CITY OF RAMSEY LAND USE APPLICATION
TECHNICAL REVIEW FILE

DATE	05/07/2015	PROJECT ADDRESS	15153 NOWTHEN BOULEVARD
PROJECT. TITLE	HARVEST ESTATES (PRELIMINARY PLAT)		
ESCROW #	114538		
DEPARTMENT:	Community Development: Planning Division (Comprehensive Plan and Zoning Code)		
PRIMARY CONTACT:	Name: Tim Gladhill Phone: 763-433-9826 Email: tgladhill@cityoframsey.com		
TECHNICAL REVIEW ASSISTANCE:	Name: Tina Goodroad, AICP Phone: 763-496-6751 Email: tgoodroad@loucksassociates.com

DATE	MAY 7, 2015	PROJECT ADDRESS	WEST OF HELIUM STREET SOUTH OF 152 ND WAY
PROJECT. TITLE	HARVEST ESTATES PRELIMINARY PLAT		
ESCROW #	114649		
DEPARTMENT:	Engineering		
TECHNICAL REVIEWER:	Name: Leonard Linton Phone: 763 433-9834 Email: llinton@ci.ramsey.mn.us

We offer the following comments regarding your request for the Preliminary Plat of Harvest Estates. The submittal consists of 26 sheets prepared by Hedlund Engineering Services dated April 29, 2015.

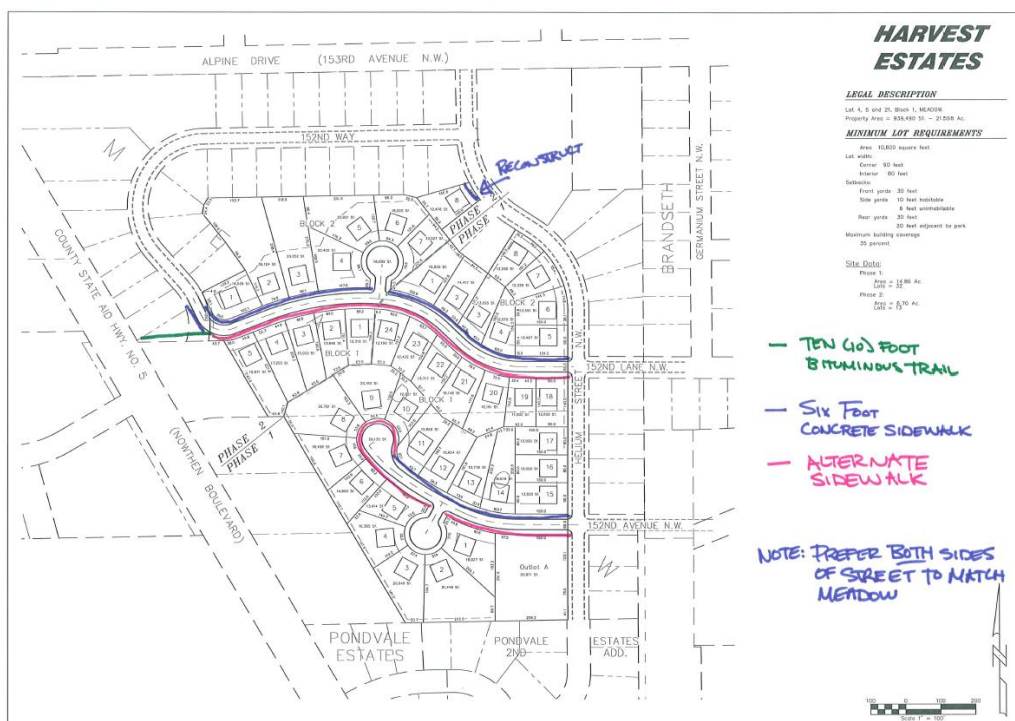
The proposed closure of the access driveway at Nowthen Boulevard has been the source of significant debate at the Planning Commission level. The City has received a number of comments in opposition of the closure, citing additional traffic being routed to other existing streets. The Planning Commission has recommended that this access should remain open if the Plat is to be approved. A summary of questions raised at the Public Hearing and initial responses are included with the May 12, 2015 City Council Case.
